Metro West Joint Development Assessment Panel Agenda

Meeting Date and Time: 25 March 2020, 9:00 AM
Meeting Number: MWJDAP/263
Meeting Venue: Department of Planning, Lands and Heritage
140 William Street
Perth

1. **Approve** DAP Application reference DAP/19/01706 and accompanying plans (Plans SK0, SK0.5 and SK01-SK36 inclusive dated 28 February 2020) in accordance with Clause 68 of Schedule 2 (Deemed Provisions) of the Planning and Development (Local Planning Schemes) Regulations 2015, and the provisions of the City of Nedlands Local Planning Scheme No.3, subject to the following conditions:

NORTH FACADE ELEVATION

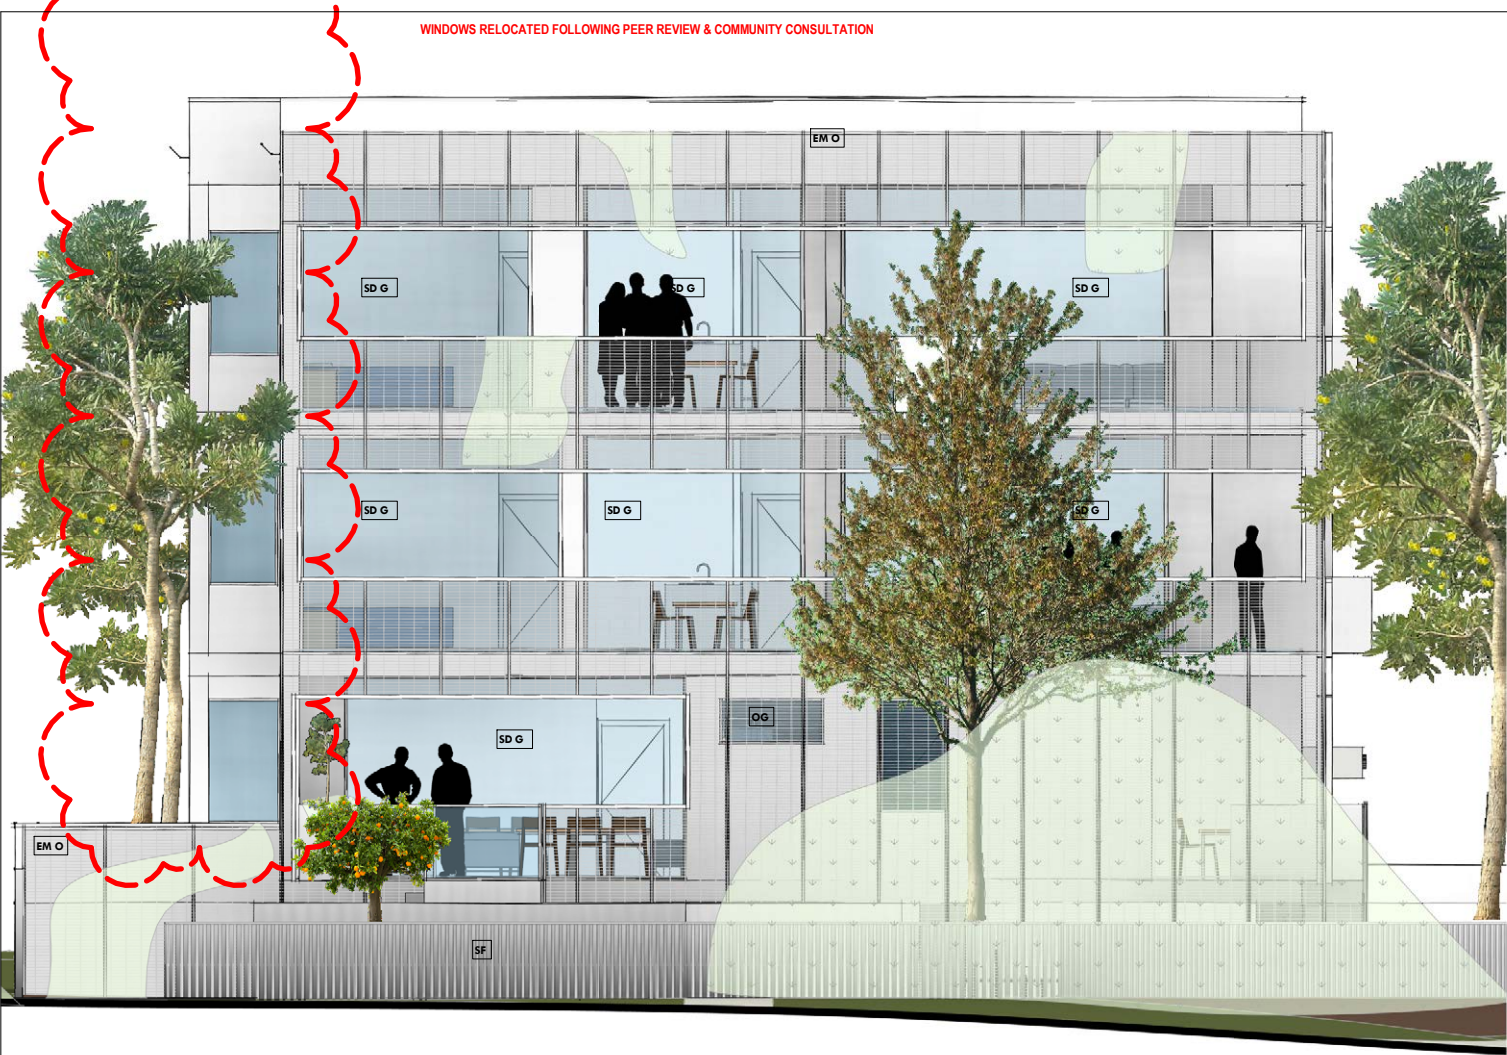
WINDOWS RELOCATED FOLLOWING PEER REVIEW & COMMUNITY CONSULTATION

SOUTH FACADE ELEVATION

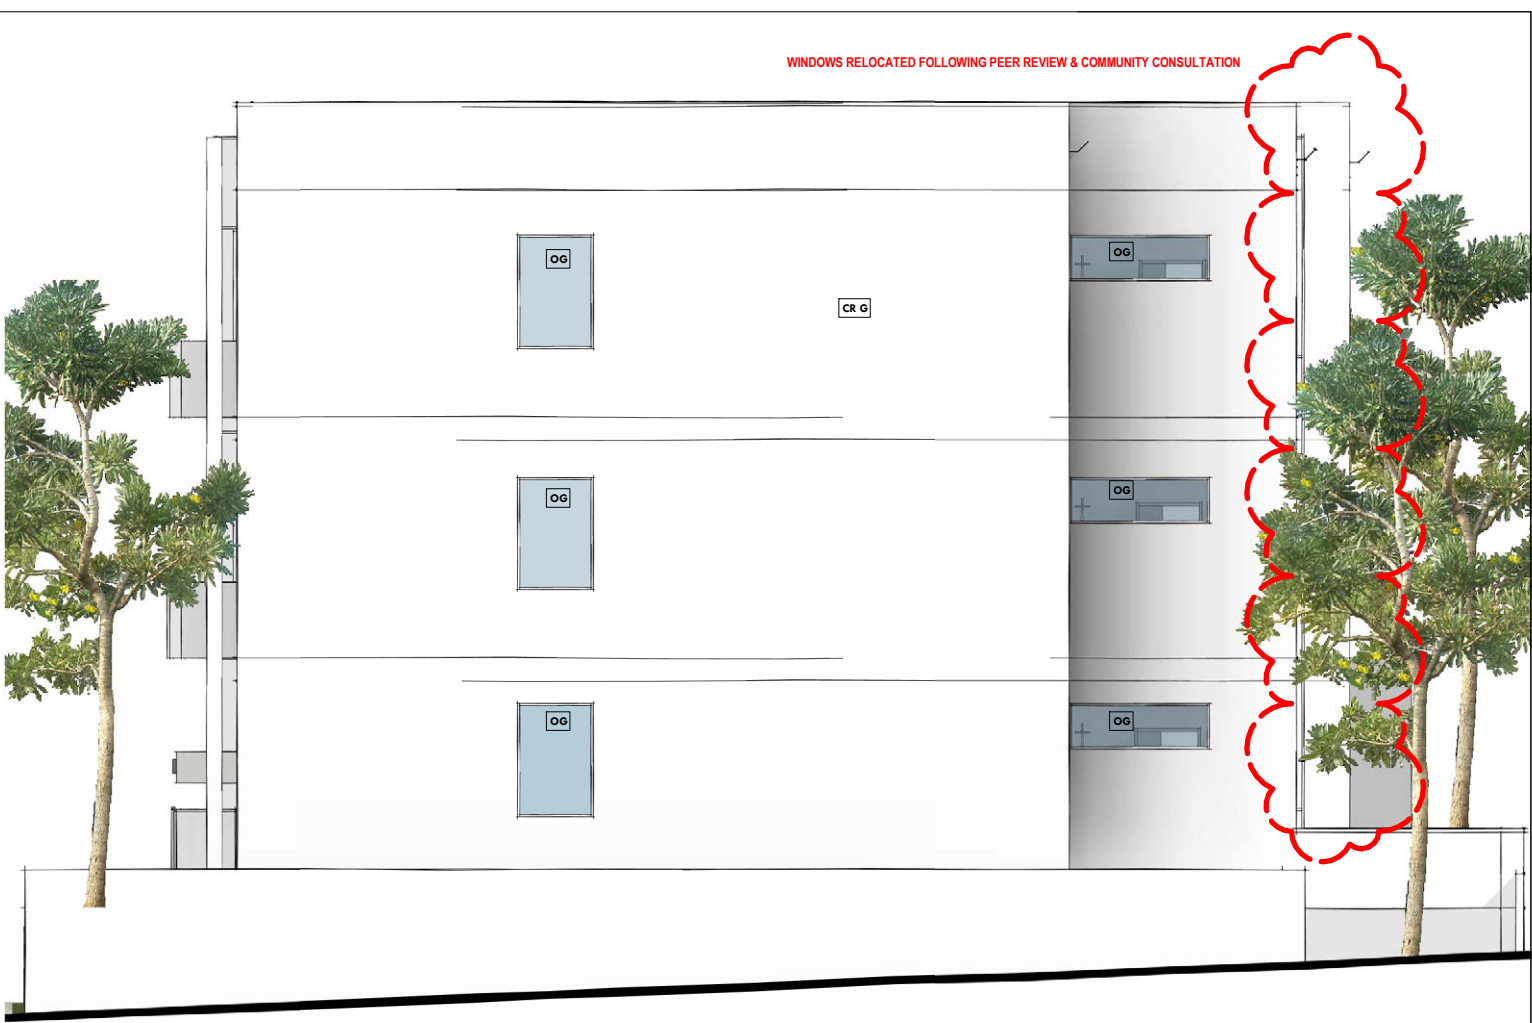
WINDOWS RELOCATED FOLLOWING PEER REVIEW & COMMUNITY CONSULTATION
